Subject: RE: O8W-PM 35217268, 35224712, 35224713 - Bucks Creek 1101 Phase 1,2&3 - Pre-Engineering Meeting

PM 35217268 (Phase 1)

PM 35224712 (Phase 2)

PM 35224713 (Phase 3)

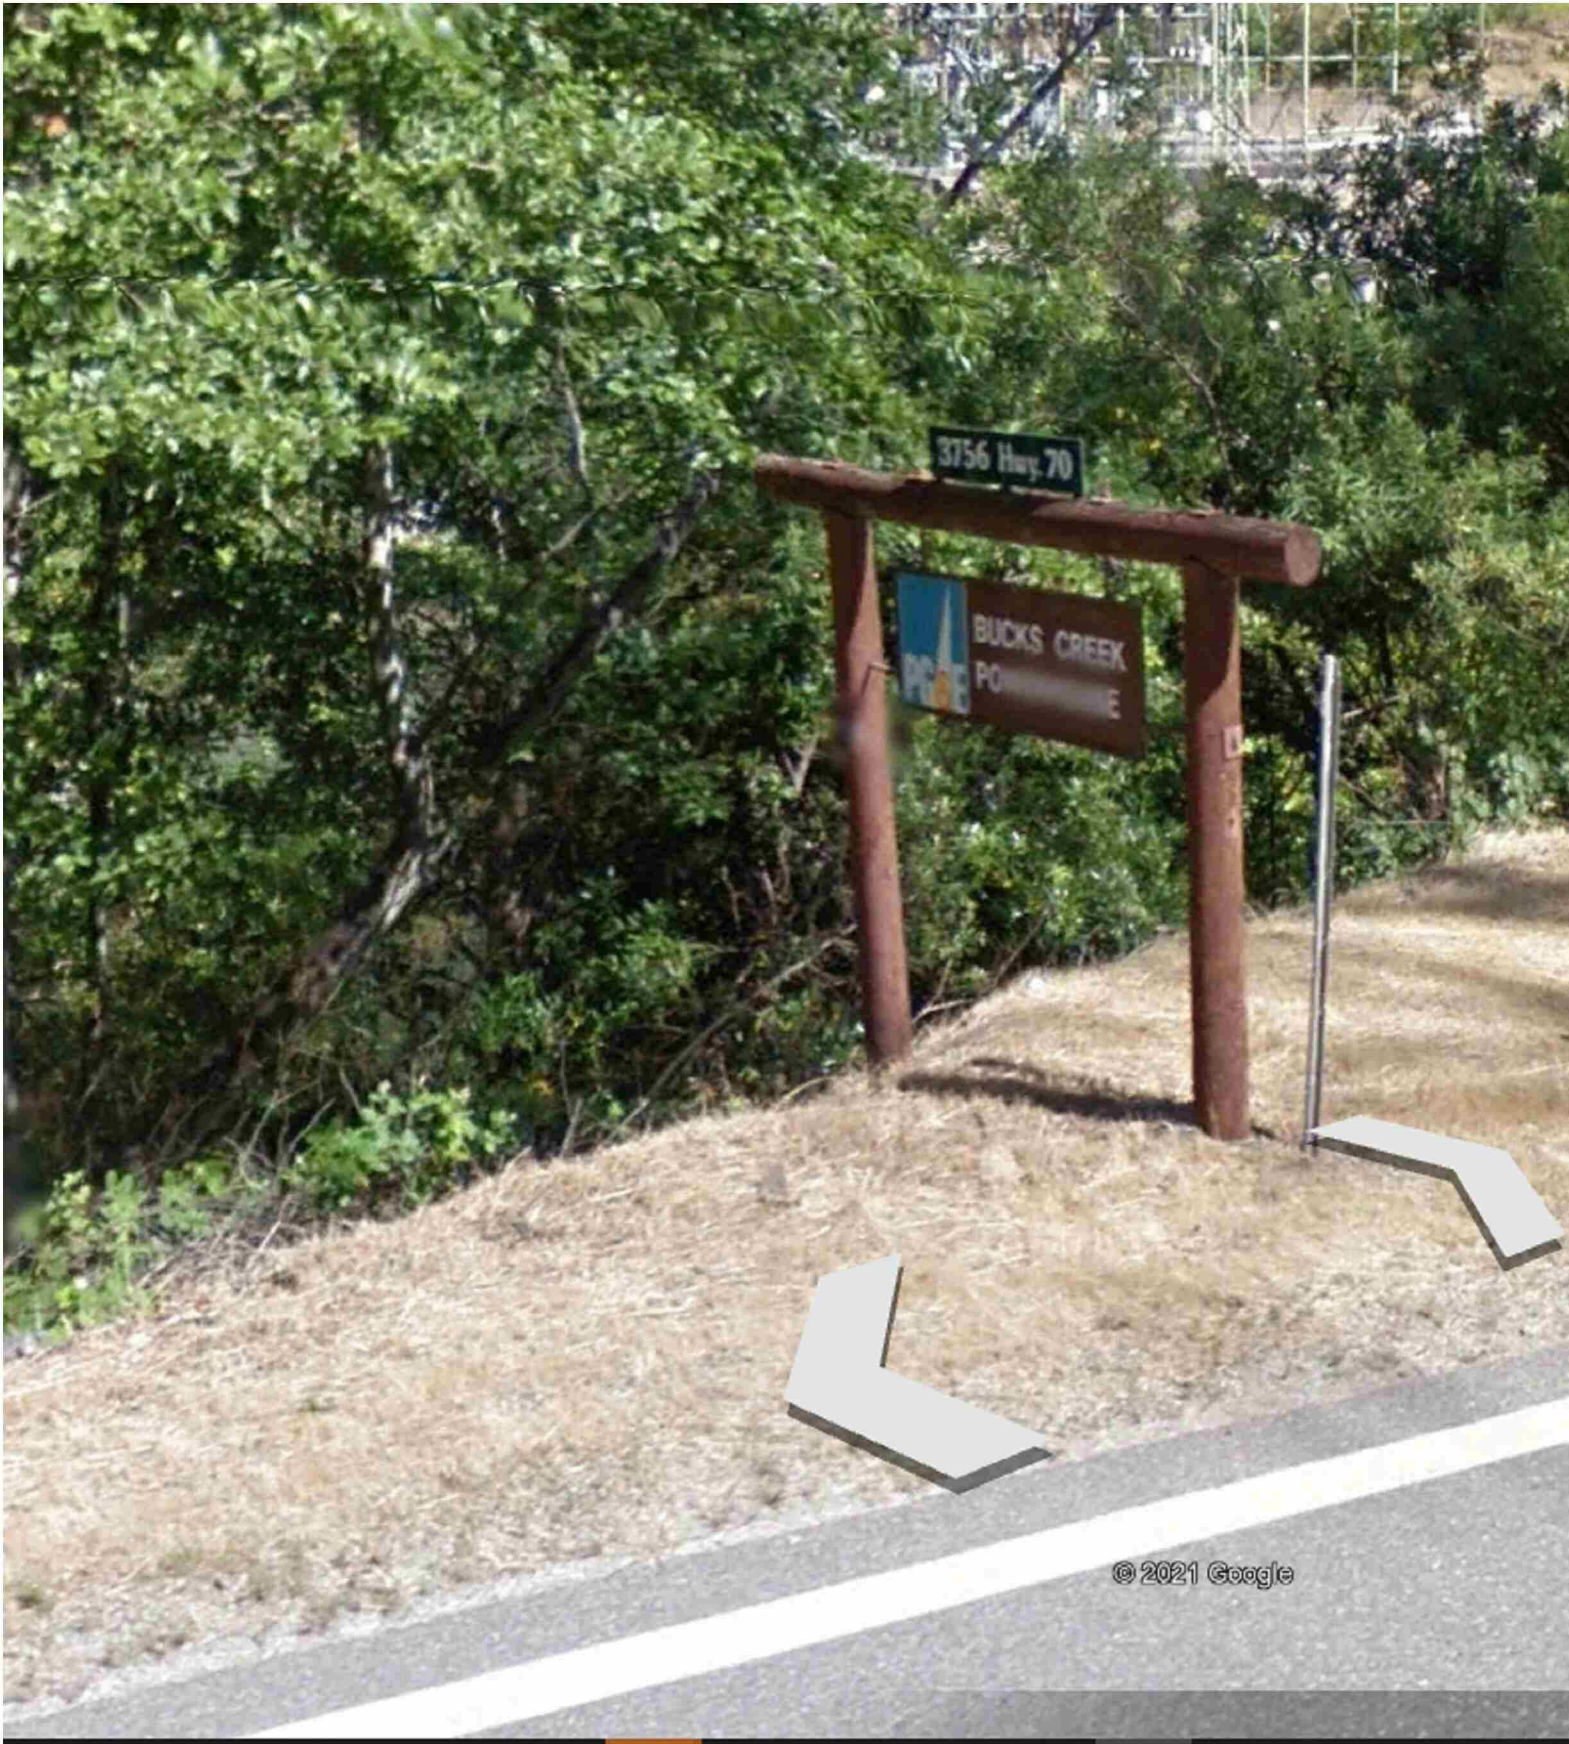
Attached are the 'base-map' limits in a kmz. file. As you will see, we need our base-map to go about ~100' into the tunnel at the south end (see pedestal in picture below....please begin about ~50 beyond this point which is about ~100' beyond the Cresta Dam).

Bucks Creek 1101- PM# 35217268 Overview Map

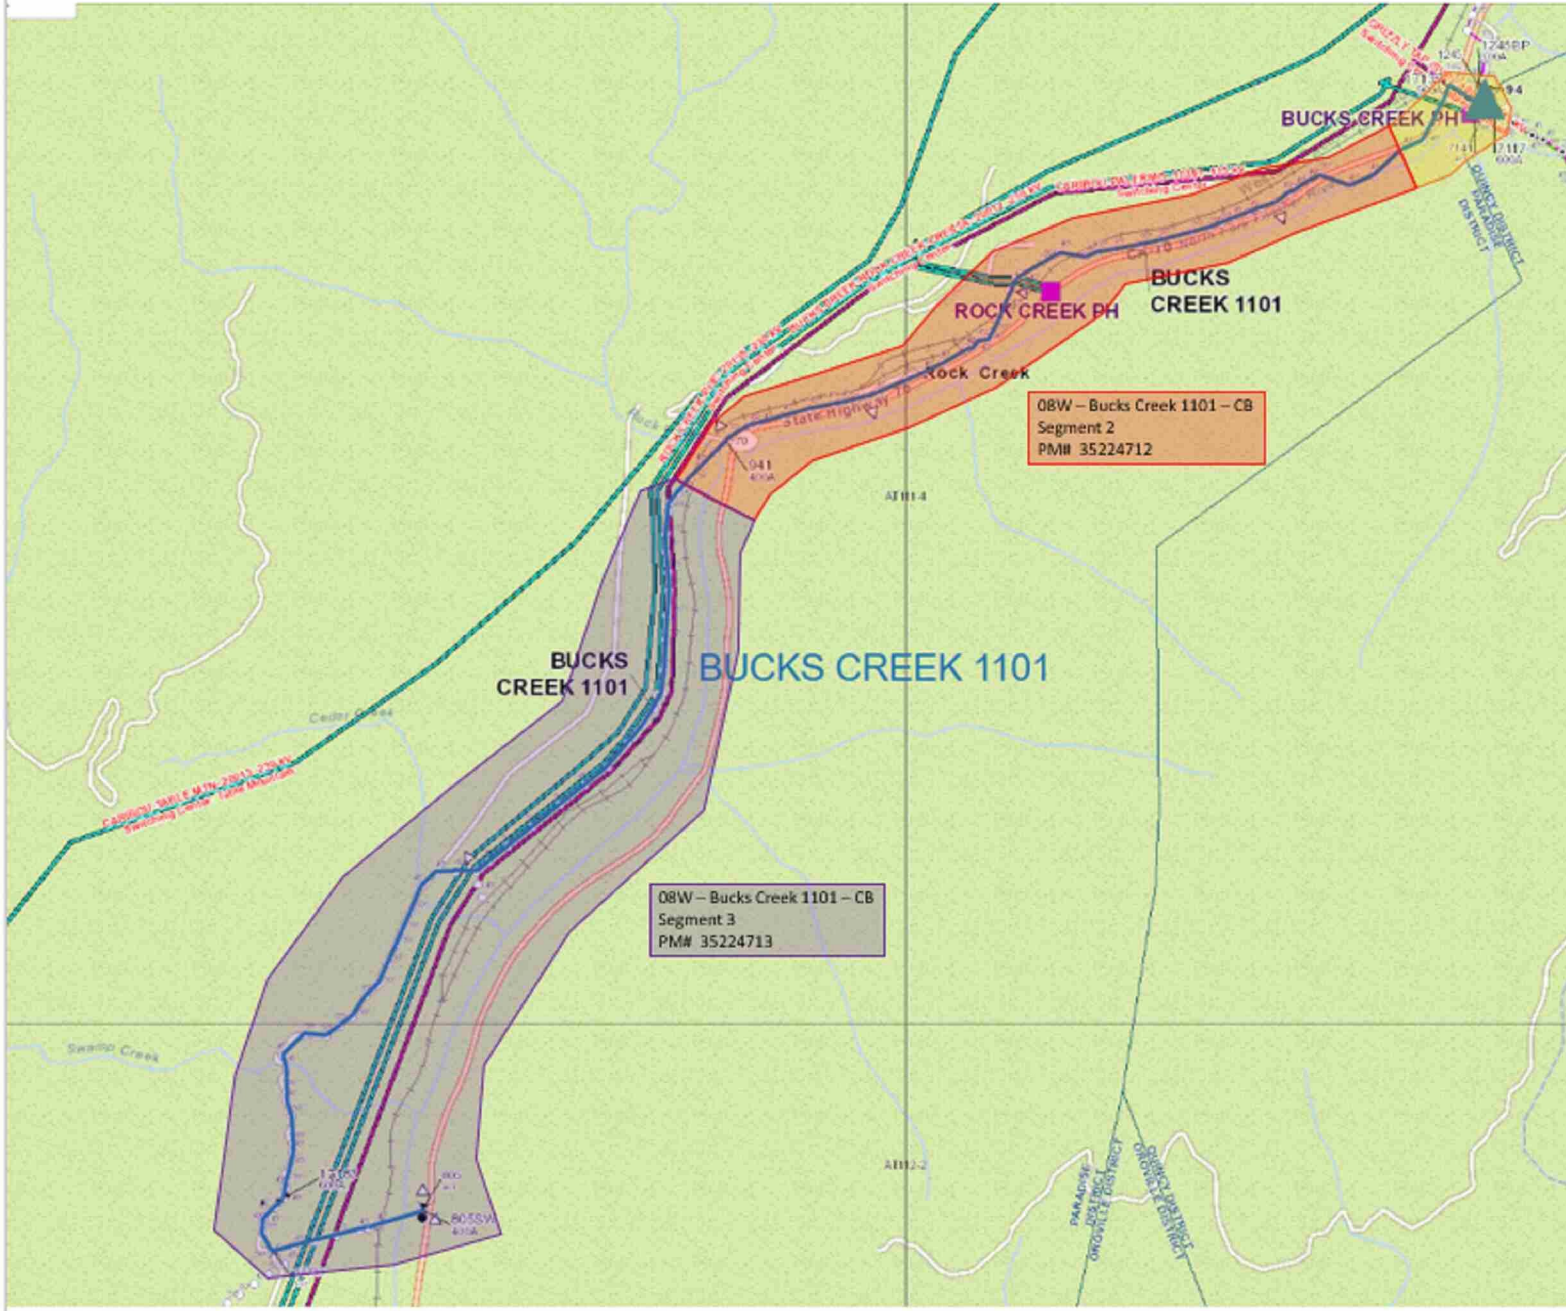
For Bucks Creek there is quite a bit of work surrounding Hwy 70 and we will need a Land Department Base Maps prepared for all 3 Orders. This will delay the EOD dates until these can be developed and provided to the Vendor... We will also need answers to the questions outlined by [REDACTED] below...
